**DEFENSE NUCLEAR FACILITIES
SAFETY BOARD**

Staff Report

October 2, 2018

H-Canyon Exhaust Tunnel Fragility Analysis Input and Assumptions

Figure 3. Diagram of HCAEX Tunnel wall concrete considered and discounted in the fragility analysis.

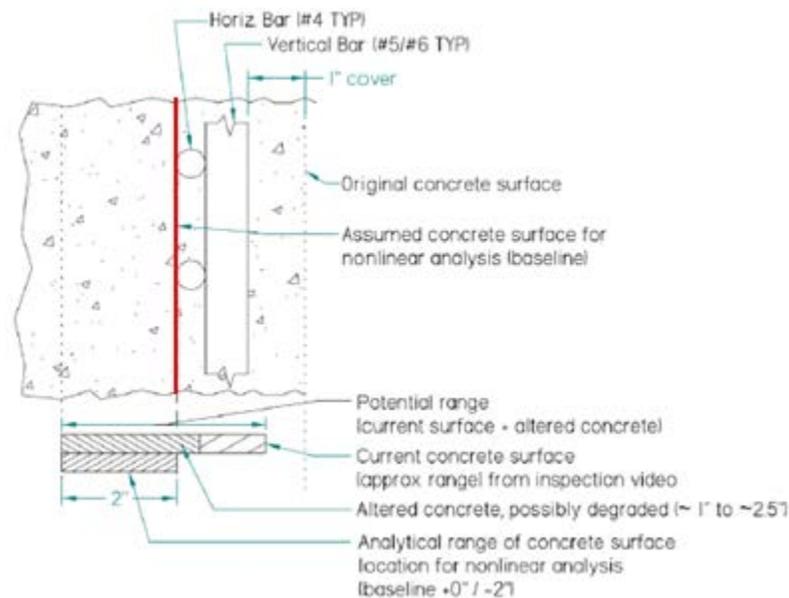
Concrete Loss—SRNS engineers have proposed three depths of concrete loss in their non-linear modeling of the HCAEX Tunnel structure: 0, 1, and 2 inches of concrete loss. These

depths are measured from the inside face of the inner reinforcement layer (red line in Figure 3). Thus, the 0 inch case represents over 2 inches of absolute wall thickness lost from the as-constructed concrete walls, floor, and roof. None of the three cases credit the tensile capacity of the inner reinforcement. As previously stated, these different levels of concrete loss are how SRNS is taking into account degradation of the concrete affected by the HCAEX environment. SNRS's non-linear fragility analysis uses analytically robust, but simple rotational springs, which assume uniform concrete compressive strength through the thickness of the HCAEX Tunnel walls [6] [18].

SRNS engineers stated during the staff review that the 0 inch (baseline) case was a conservative starting point because only some of the crawler inspection photos taken showed both layers of inner reinforcement exposed. Based on the most recent crawler inspections showing large areas of the tunnel with both layers of interior reinforcement exposed, the staff team concludes that the baseline condition is more accurately described as being representative of the current HCAEX Tunnel condition rather than as a conservative starting assumption [19]. While the distinction between conservative and appropriate described above may seem of little consequence to the non-linear fragility analysis, SRNS engineers explained to the staff team that this "conservatism" is a further reason why a 95th percentile concrete compressive strength of 2500 psi is acceptable for the affected and unaffected concrete.

Critical Point of Degradation—Given the ongoing concrete degradation and section loss, the staff team concludes that it would be appropriate to analytically consider section losses beyond two inches relative to the baseline in Figure 3 in order to inform on the future configuration of the HCEAX Tunnel. The remaining material on the inside face of the tunnel walls, roof, and floor is undergoing or will eventually begin to undergo chemical alteration and a concomitant decrease in strength. SRNS engineers stated that they intend to do additional analysis to determine the depth at which the tunnel cannot meet its performance goal, but will not include these results in the non-linear fragility analysis. If the depth of degradation determined is close to the depth at which nitrate-bearing concrete is in the HCAEX Tunnel walls, it may be prudent to consider this information in the non-linear fragility analysis. Additionally, knowing this value in combination with inspection of the tunnel informs the future viability of the HCAEX Tunnel structure.
